Origination Form
Proposed Revisions to a Standard Plans Index

Originator:	Stepp, Richard	Index Number:	521-404
Date:	8/28/2024	Sheet Number(s):	7
E-mail:	richard.stepp@dot.state.fl.us	Index Title:	Guardrail Transitions - Existing Post and Beam Bridge Railings (Narrow and Recessed Curbs)

GUARDRAIL TRANSITION DETAILS - SHEET 2 OF 2

SCHEME 5

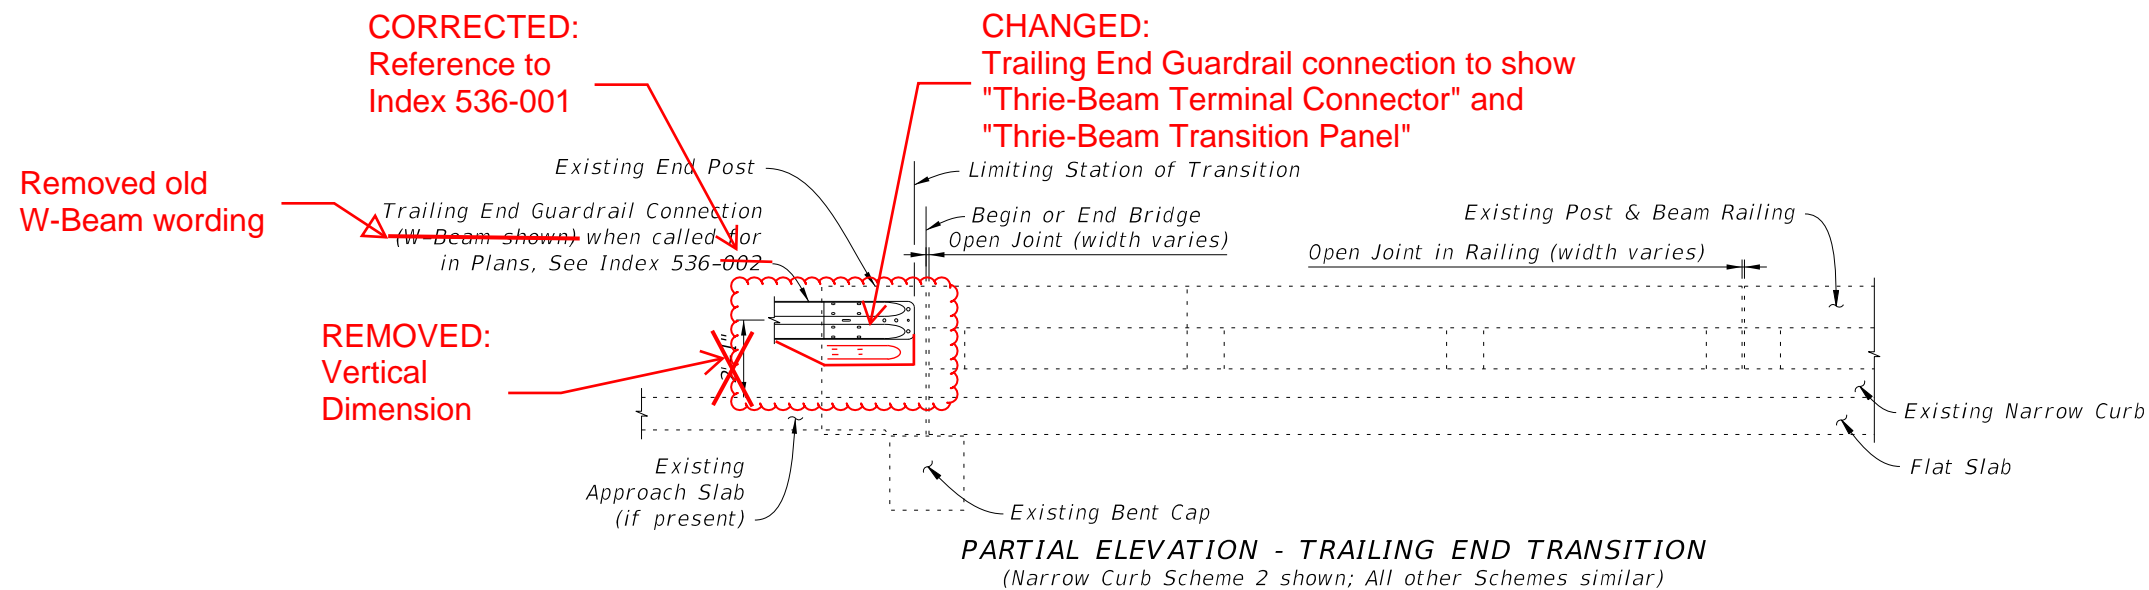
Sheet 7: SCHEME 5 - Changed "W-Thrie Beam" wording to "Thrie-Beam"; SCHEME 6 - Changed Trailing End Guardrail Connection to show a Thrie-Beam Terminal Connector, Corrected reference to Index 536-001.

CHANGED: "W-Thrie Beam" to "Thrie-Beam"
